Government of the District of Columbia
Department of Consumer and Regulatory Affairs

Office of the Zoning Administrator

RE: 2216 Rhode Island Avenue, NE (Square 4248, Lot 0022)

This letter summarizes the meeting with my staff at the Preliminary Design Review Meeting (PDRM) on December 5, 2019, regarding the proposed renovation of the existing commercial building located at 2216 Rhode Island Avenue, NE. This letter summarizes the points of the discussion during the meeting and to confirm my determination regarding your proposed project.

Zoning Calculations
 Project Number: _____
 Date: _____
 Drawn by: _____
 Checked by: _____
 Scale: **Z-100**

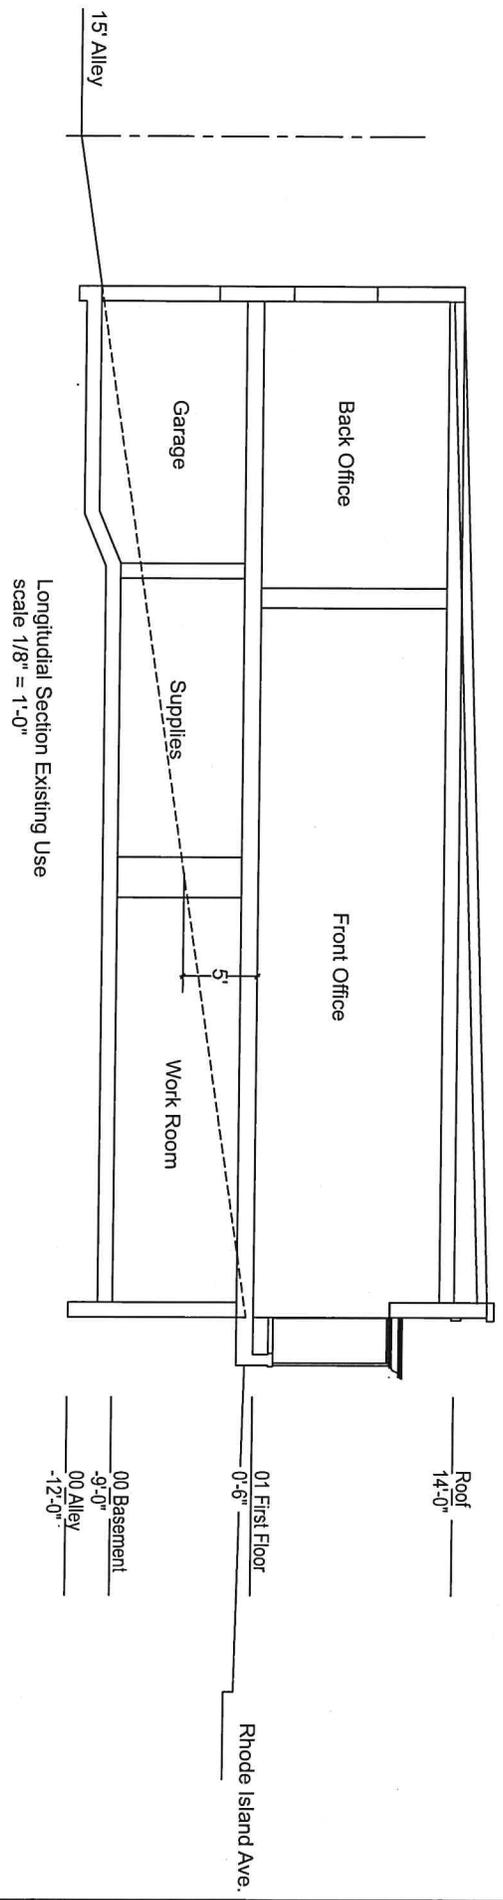
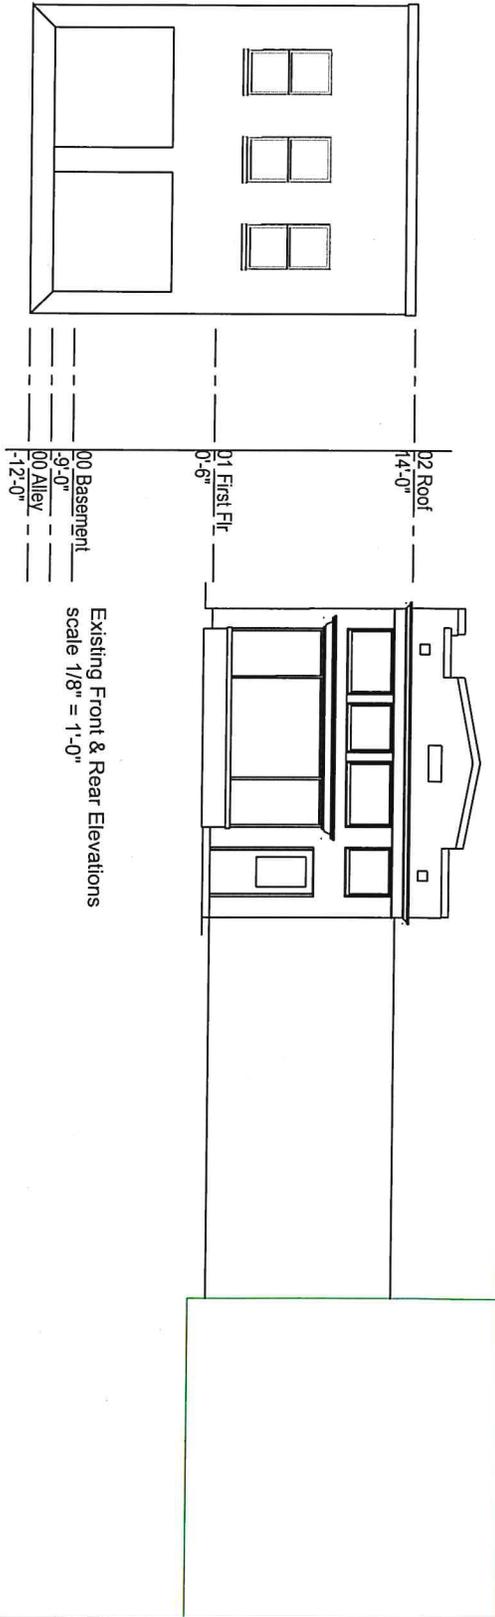
- Total FAR 2.5 = 3,968.5sf
 - Max commercial FAR 1.5 = 2,381.1sf
 - Each floor area of the existing building = 1,378.44sf
- The proposed renovation of the existing building will use the following Zoning Regulation, 11-B DCMR 304.5 to reduce the footprint of the existing building.

- Total basement are = 1,378.44sf, cellar area = 520.44sf excluded
 - Total commercial area 1,378.44sf + 858.0sf = 2,236.44sf
- Apartment addition at the second and third floor is limited to 60% of lot area = 952.44sf max each floor.

- Max FAR = 3,968.50sf – 2,236.44sf commercial = 1,732.06sf residential
- Proposed roof deck over the existing commercial space will be located at the rear behind the 15ft. rear yard setback, but the deck can be located at that point meeting the requirement for the deck guardrail, 1 to 1 setback.
